SERVICE BULLETIN

M-1365

April 7, 2014

XL FORWARD CONTROL KIT BRAKE PEDAL REPLACEMENT

Figure 1. Brake Pedal

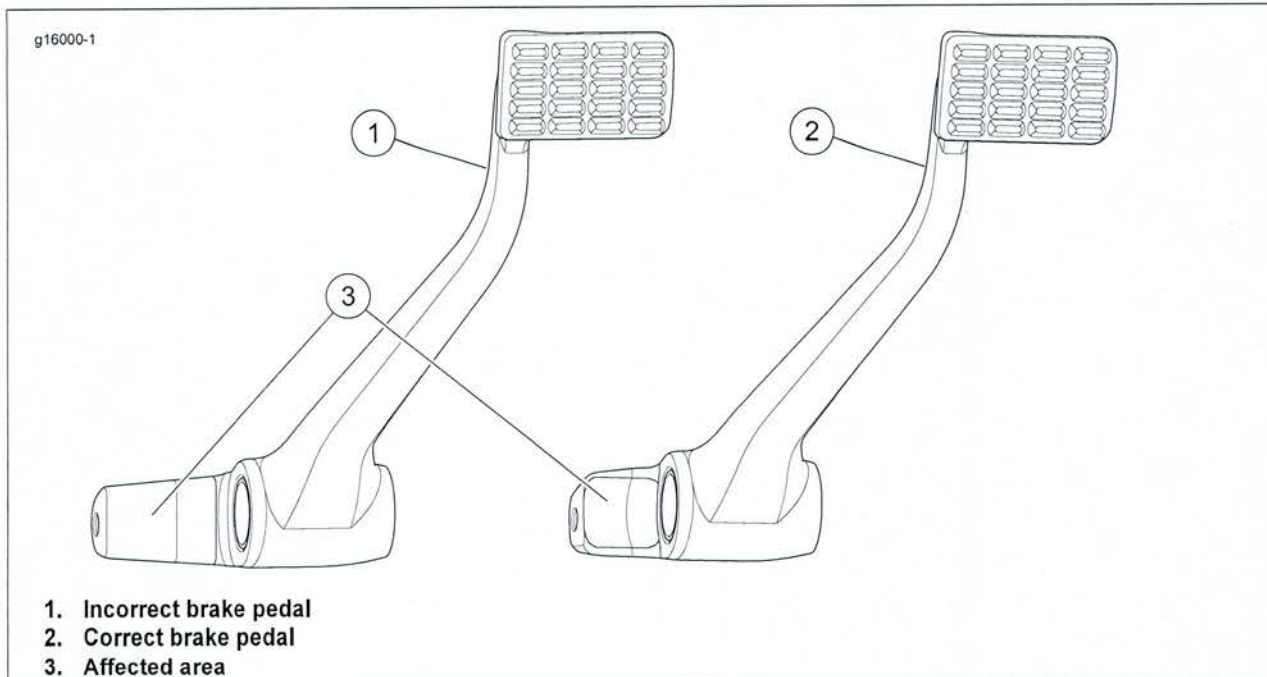
Forward Control Kits (Part No. 50700020), including brake pedal (Part No. 50600111), shipped before February 10, 2014 contained an incorrectly manufactured brake pedal.

1. See Figure 1. Inspect affected area (3) of brake pedal. Correct brake pedal (2) has shorter boss.
2. See Figure 2. When installed, incorrect pedal (2) is in position shown.
3. All kits or brake pedals shipped before February 10, 2014 will require a new brake pedal (Part No. 50600111).
4. Inspect current inventory of Harley-Davidson Forward Control Kits (Part No. 50700020 and brake pedals (Part No. 50600111). Contact any retail purchasers of Part No. 50700020 or 50600111 and inspect pedal. Order new brake pedals as needed.
5. Remove and replace the brake pedal in all affected Forward Control Kits, or component brake pedals in your inventory with a **new** pedal. Contact any retail purchasers of Part No. 50700020 or 50600111 and replace the original brake pedal with the **new** brake pedal.
